Reply to Office Action and Amendment

Serial No. 09/775,425
Reply to Office Action and Amendment

FIG-7

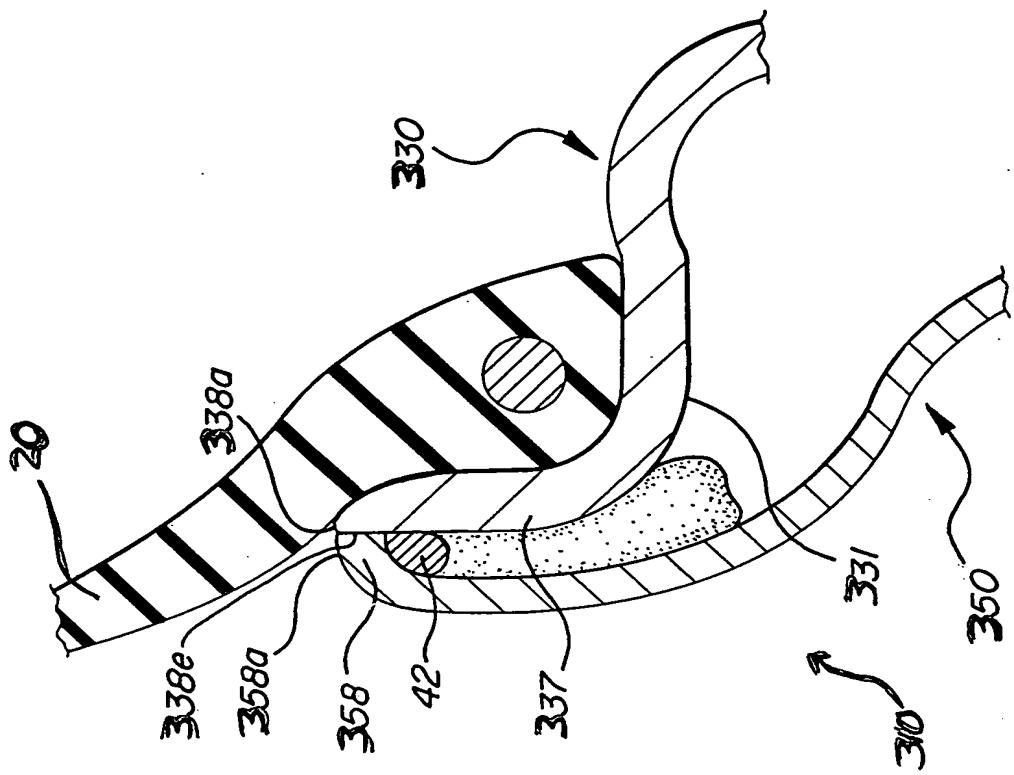
Figure 9, kindly add numeral 610, and amend numerals 30, 37, 38a, 38x, 50, 57, 58, and 58a to now read 130, 137, 138a, 138x, 650, 657, 658, and 658a, respectively.

The requested amendments are indicated in red on the attached marked-up copy of the drawings. Two marked up copies are enclosed to facilitate this request.

FIG. 10B

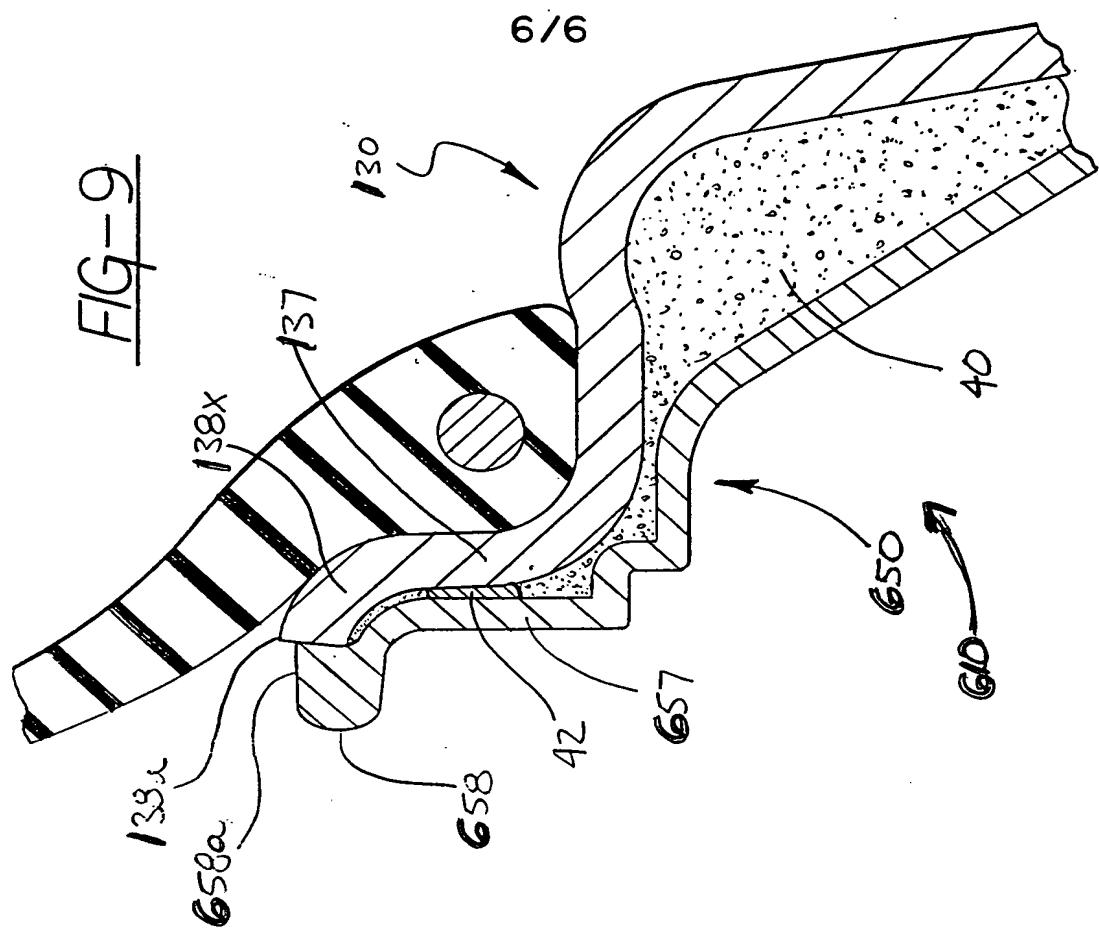
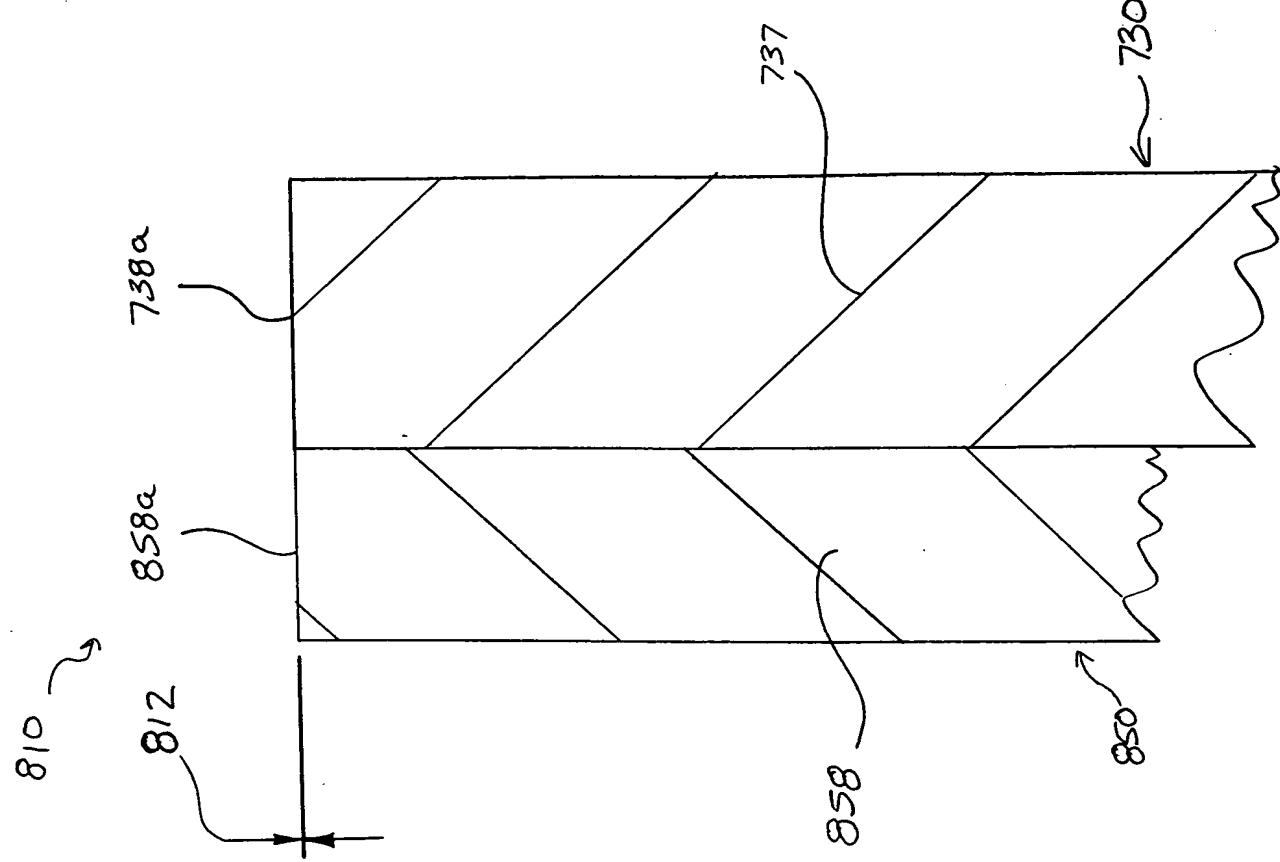
In the Office Action the Examiner objected to the drawings under 37 CFR §1.83(a) for failing to show some of the features of Claims 1, 7, 12, 21 and 26. Specifically, the Examiner noted in item 1 of the Office Action that showing the margin would merely require a line be drawn near the flange lip of the wheel. It is not practical

to attempt to show the margin in the existing drawing figures since all of the Figures are particularly busy with drawing lines, leader lines, and numerals, and also since the drawings are not dimensional drawings but merely exhibit features of the invention. The specification clearly discloses the margin and a person skilled in the art will clearly understand this feature from the description in the specification. Nonetheless, Applicants' attorney elects to submit herewith additional enlarged drawing Figures 10A and 10B that more clearly illustrate the margin per the Examiner's request. As described in the originally filed specification at page 19, lines 8-24, and page 20, lines 1-16, and page 22, lines 13-15, the margin of the preferred embodiment can be specified as 0 mm per side with a unilateral tolerance of -1.6 mm. Therefore, Figure 10A shows the margin at one end of the extreme of -1.6 mm, and Figure 10B shows the other end of the extreme with the margin of 0 mm.
